RE: Calico Solar (Formerly Solar One) Project  
Applicant's Submittal of the Calico Solar Drainage Layout Figure

**DRAINAGE LAYOUT  
 CALICO SOLAR PROJECT**

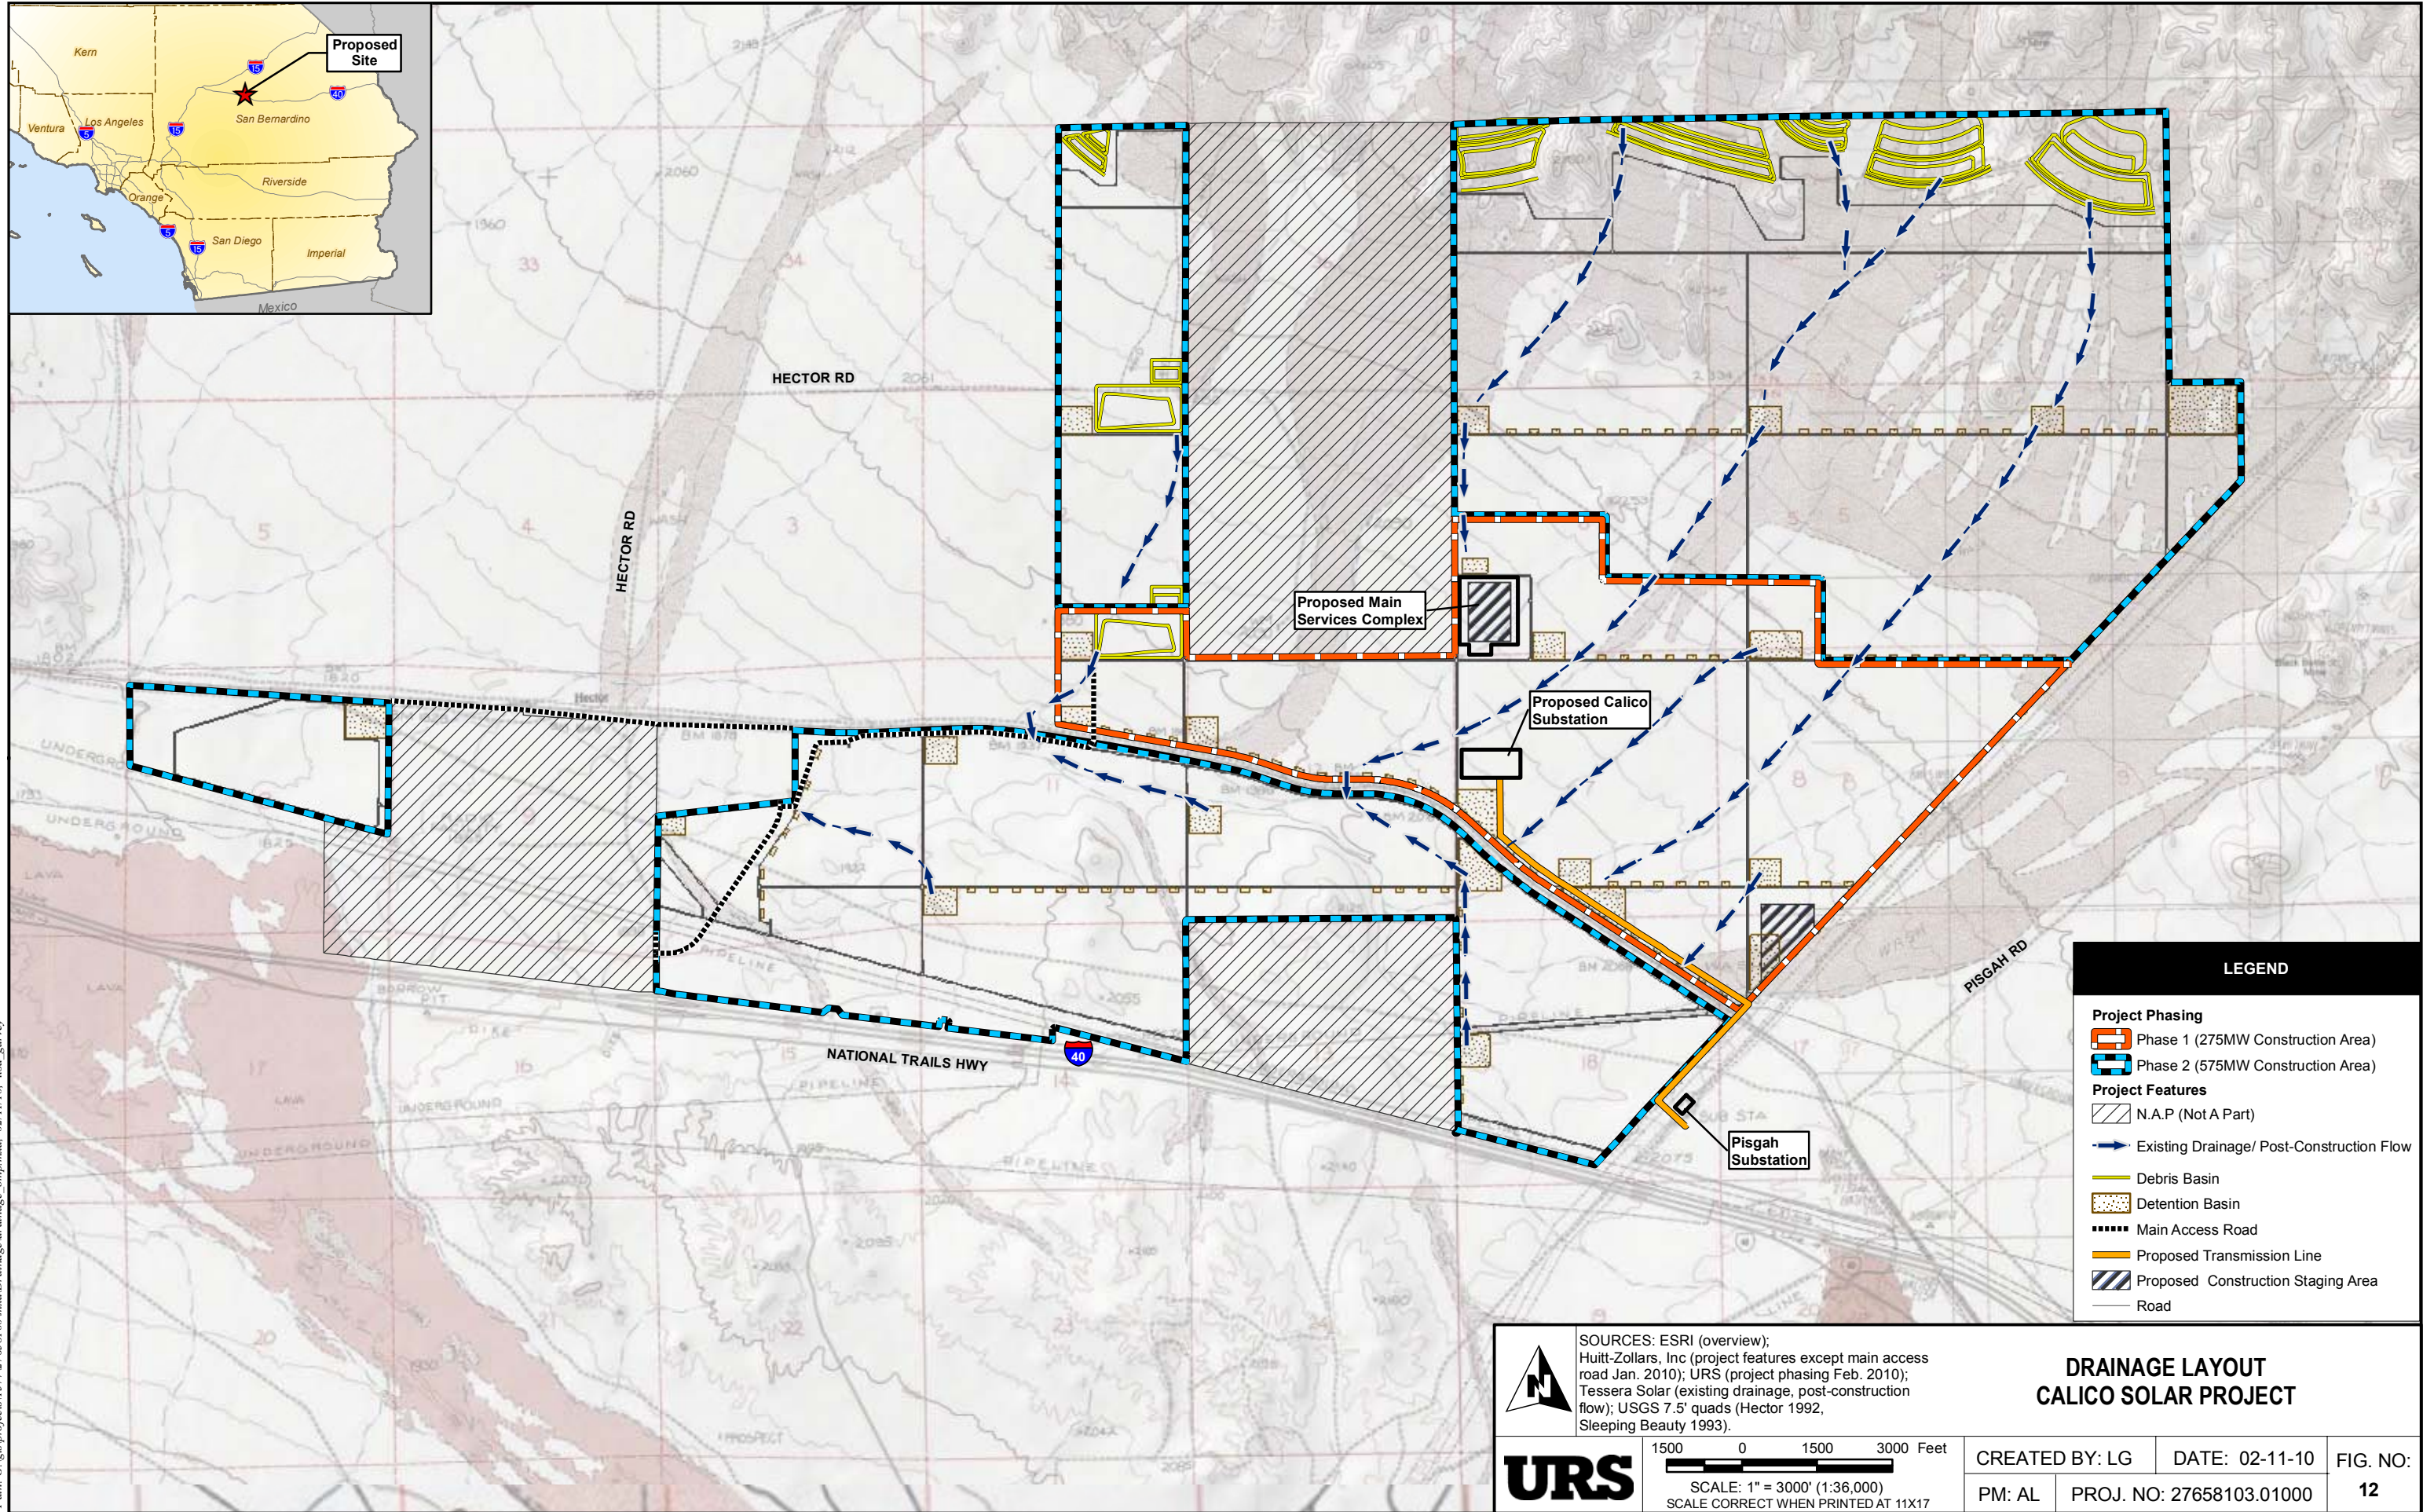
Tessera Solar hereby submits the Applicant's Drainage Layout figure for the Calico Solar Project. As identified during the workshop continuation on January 5<sup>th</sup>, 2010, Figure 12 of the Biological Resources Technical Report was incorrect. The Applicant then submitted a figure showing Alternate Four from the Hydrologic Assessment for interim use. The attached figure incorporates the concept of the Alternate Four, but includes current Project boundaries. I certify under penalty of perjury that the foregoing is true, correct, and complete to the best of my knowledge.
